Intersection ID: 4428	Main Street: LONG_CREEK_PARK_DR	Cross Street: STATESVILLE_RD	Location:	NW
ADA ID: 8541B88CD3A2	Ramp Type: BlendTrans1	Initial Pass/Fail: Fail	Overall Compliance: No	Severity Score: 0

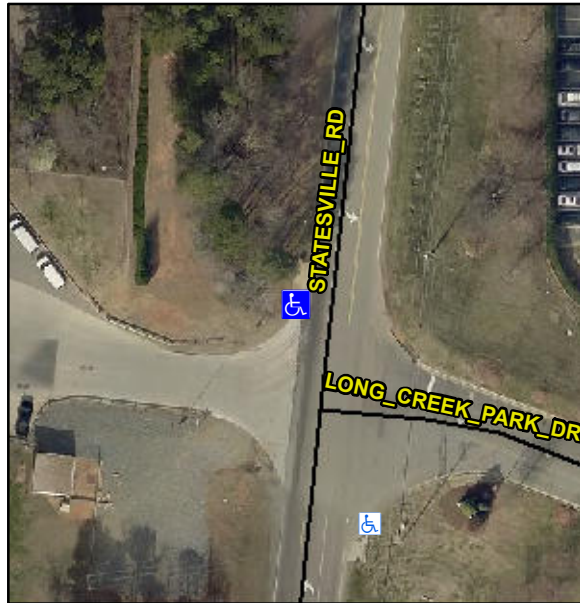
Surveyor Notes:

**NO CURB**

**Remove & Replace Curb Ramp With Two New Directional Ramps or Equivalent.**
